Council Reference: A006721031

RE: Notice of Minor Change and Withdrawal of Notice About Stopping Current Period for a Development Application for a Development Permit for Multiple Dwelling and Food and Drink Outlet upon land at 299 Coronation Drive, Milton

2.0 Summary of Proposed Changes

Figure 1: Ground level design strategy highlighting public realm activation and subtropical design integration (axonometric diagram)

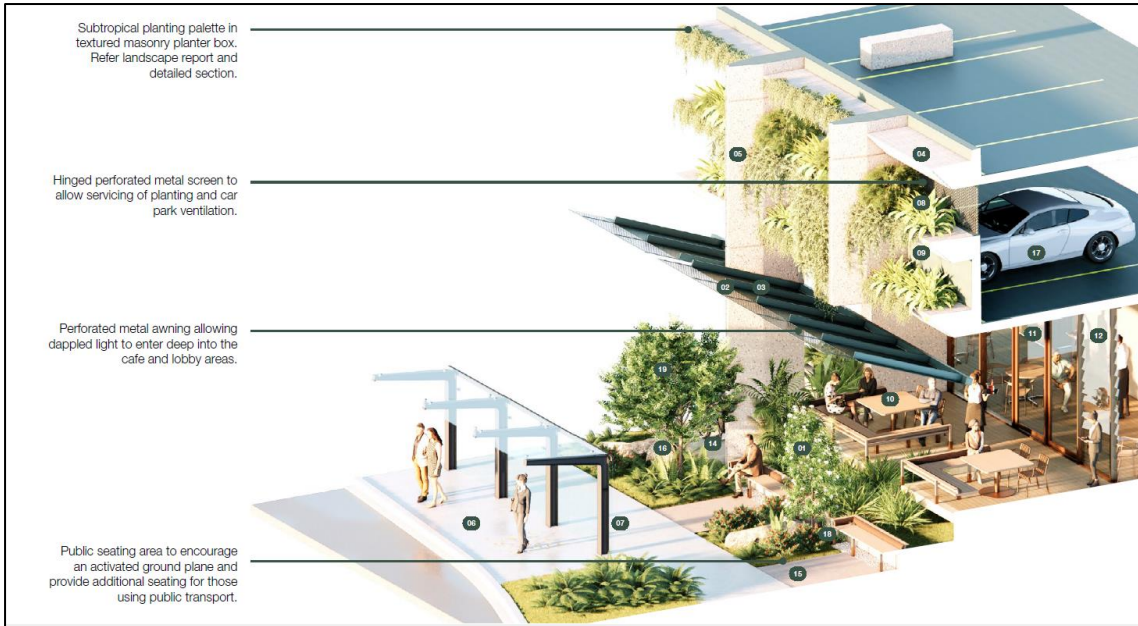
- Addition of a new community seating area adjacent to Coronation Drive.
- Revised layout of café seating areas, with clearer planting integration and spatial definition.
- Enhanced landscape interface at the Graham Street corner including plaza seating, stepping stones and planting.
- Improved ramp gradients, widened footpaths, and better alignment with the existing verge and infrastructure.

- Increased activation along the Coronation Drive frontage, including improved integration with the existing high-frequency bus stop.

Figure 5: Tower façade articulation and subtropical balcony design

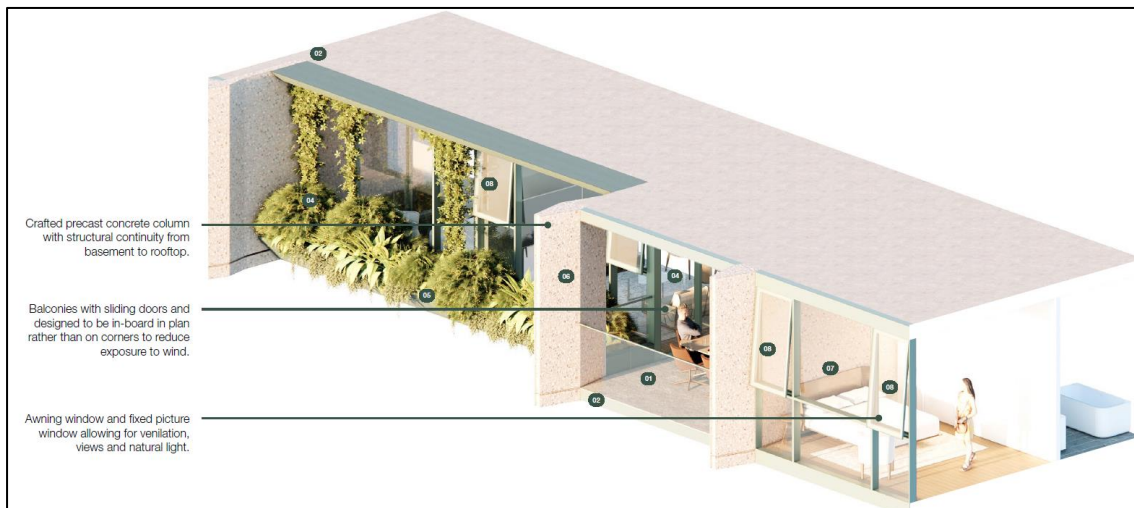
- Vertical breaks have increased in the revised scheme from the original design to create a more sculpted and responsive tower form.
- Building articulation now integrates extensive subtropical planting through textured planter boxes, in board balconies, and operable elements that contribute to ventilation and shading.

- The ground plane has been carefully reworked to reflect human scale principles, with dappled light from perforated metal awnings, textured masonry, sandstone tiling, and integrated bus stop seating supporting a subtropical and community focused frontage.

Figure 6: Revised Tower Floor Plate – Articulation and Break Strategy

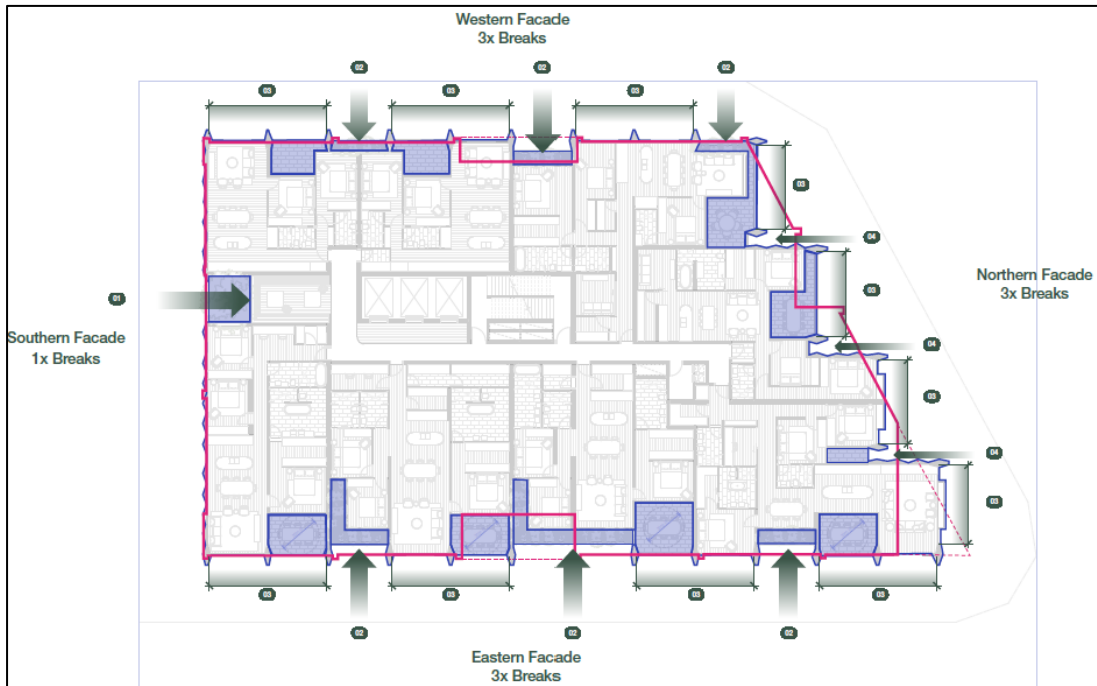
This diagram illustrates the refined typical tower floor plan, highlighting improved façade articulation and design responsiveness. The proposed design introduces multiple vertical and horizontal breaks across all frontage – three each to the eastern western and northern facades, and one to the southern elevation. These breaks are reinforced by deep articulation zones and strategically recessed balconies or planters resulting in a more sculpted and visually dynamic built form.

Compared to the previous approved outline (shown in pink), the proposed footprint reflects a more nuanced architectural response. The additional of green punctuation elements softens the building’s massing while enhancing its subtropical character. These measures significantly improved the perceived bulk and scale of the tower, deliver greater modulation and shadow plan, and reinforce design excellence outcomes consistent with the Buildings that Breathe and New World City Design Guide principles.
